Appendix A: Public Comments and Responses

The NOA for the Draft EIS was published in the Federal Register on April 19, 2024, at which time the 45-day comment period commenced and ended on June 3, 2024. The BLM held three public comment meetings: (1) May 6, 2024 at the Dyer Community Center, (2) May 7, 2024, at the Tonopah Town Hall in Tonopah, Nevada, and May 9, 2024 as a virtual meeting. A total of 15,622 comment letters from agencies, businesses, organizations, and interested parties were received on the DEIS via mail, email, or the Rhyolite Ridge ePlanning website. All comments on the DEIS that were received were read and given careful consideration. Each comment was included in a comprehensive database, analyzed for its content, and appropriate responses were prepared. In some cases, the comments provided information or suggested changes that were incorporated into this FEIS.

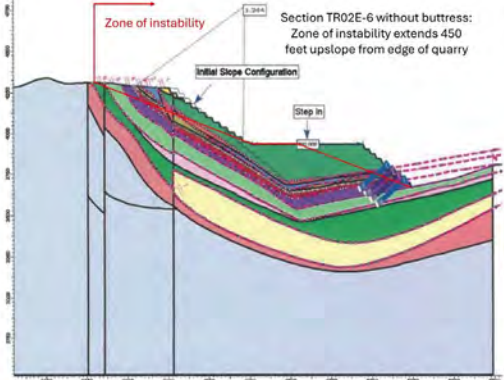
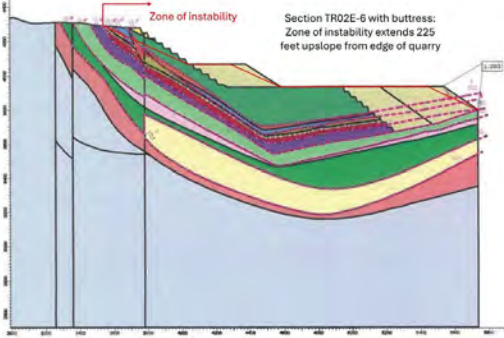
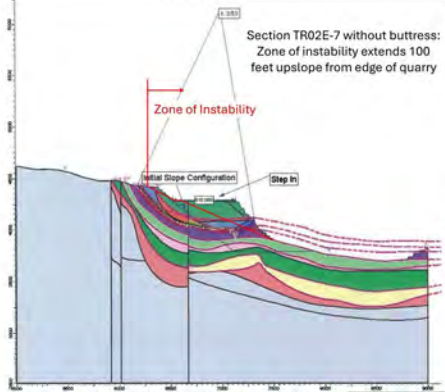
108 and 183	108.50 and 183.49	<p>RESPONSES</p> <p><i>The Calculation of the Factor of Safety is Unreliable</i></p> <p>There are multiple grounds for concluding that the calculations of the factor of safety by Geo-Logic Associates (2022, 2023; see Fig. 15) are unreliable. Whether the minimum factor of safety of 1.2 was the correct choice is a different matter, which is discussed in the following two subsections. The geotechnical parameters for each geologic unit that were the input data for the calculation of the factor of safety are stated with ultra-precision, sometimes with as many as five significant digits (see Fig. 13). Geo-Logic Associates (2022, 2023) does not provide any information on the uncertainty in the input data that would justify such a high degree of precision. As mentioned earlier, the DEIS does not identify any source of construction material for the buttress, so the material properties of the buttress must be regarded as purely hypothetical (see Fig. 13).</p> <p>Geo-Logic Associates (2022) states that some of the material properties were obtained from a consulting report by EnviroMine (2019) that is not available for public review. In the report by EnviroMine (2019), some of the geotechnical parameters were developed from laboratory data, but the final values were based partly on the “judgment” of EnviroMine (2019). Other parameters were selected by Geo-Logic Associates (2022) without basis in documented measurements of the geologic units at the site of the proposed Rhyolite Ridge mine, so that they were presumably also based on “judgment.” According to Geo-Logic Associates (2022), “Shear strength characteristics and material properties were taken from EnviroMine (2019) and used for GLA’s analyses documented herein. Laboratory test results from EnviroMine (2019) ... The final strength values utilized for each lithology within the limit equilibrium analyses was derived from the lab testing data</p>	<p>A conservative approach was used for estimation of geotechnical parameters based on the materials encountered on site. Material properties are listed on Figure 3-5 of the GLA report.</p> <p>The material properties utilized in the analyses were derived from the EnviroMine (2019) report. The material parameters incorporated are conservative values based on the results of various laboratory tests. These conservative values provide a reliable foundation for the stability analyses, reducing the need for additional sensitivity analyses regarding the material properties. Materials Properties are listed on Figure 3-5 (GLA 2022). This conservative approach ensures that the safety factors used are robust and account for any potential variability in the material properties. Material properties are listed on Figure 3-5 of the GLA report.</p>

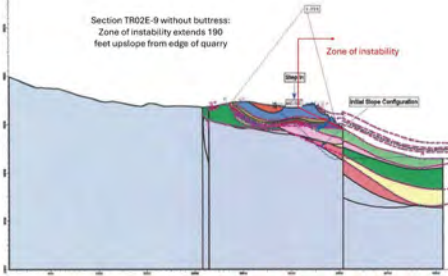
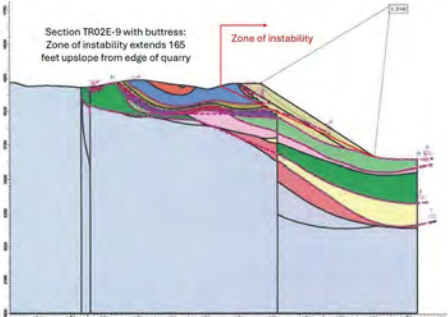
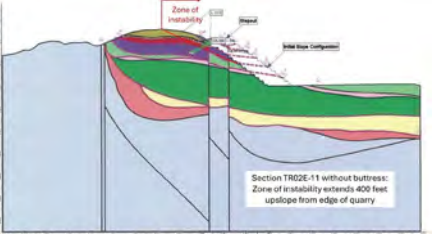
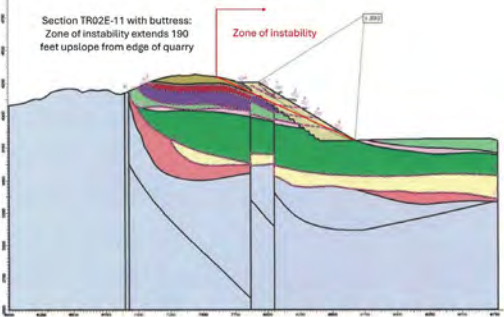
Business	No delay, cost < \$10K (e.g. small failure outside of work area)	Minor delay, \$10 - \$100K (e.g. inter ramp slope failure requires stabilisation)	Total loss \$100K - \$5M (e.g. main access ramp destroyed causing delay and re-planning)	Total loss \$5M - \$100M (e.g. production pit closed for significant period, ore sterilised)	Total financial loss > \$100M (e.g. failure large enough to close mine)																																																																																																																																																																																																
108 and 183	108.52 and 183.51	<p><i>The Choice of the Minimum Post-Closure Factor of Safety is too Low</i></p> <p>There are two main reasons as to why the minimum factor of safety must increase in the transition from the operational to the post-closure period. First, any data uncertainty during the operational period is amplified into the post-closure period. Even if there is excellent knowledge of the geotechnical properties during pit operation, there is much less certainty about the rate and extent of the degradation over time of the strength of the rock masses adjacent to the pit walls (de Bruyn et al., 2019; Carter et al., 2022; de Graaf et al., 2024). In addition, it has already been mentioned that there are still gaps in theoretical knowledge regarding the processes that drive rock strength degradation (de Graaf et al., 2024; see Fig. 8). Therefore, keeping the factor of safety fixed even as the data uncertainty increases has the potential to greatly increase the probability of failure during the post-closure period (see Fig. 24). The second reason as to why the minimum factor of safety must increase is that the post-closure period will see a reduction in or complete cessation of monitoring, as well as a reduction in or the complete absence of an onsite trained workforce. Thus, the reduced ability to detect instability or to respond to instability in a timely manner means that the probability of failure must be greatly reduced.</p>	<p>A conservative approach was used for estimation of geotechnical parameters based on the materials encountered on site. Material properties are listed on Figure 3-5 of the GLA report.</p> <p>The material properties utilized in the analyses were derived from the EnviroMine (2019) report. The material parameters incorporated are conservative values based on the results of various laboratory tests. These conservative values provide a reliable foundation for the stability analyses, reducing the need for additional sensitivity analyses regarding the material properties. Materials Properties are listed on Figure 3-5 (GLA 2022). This</p>
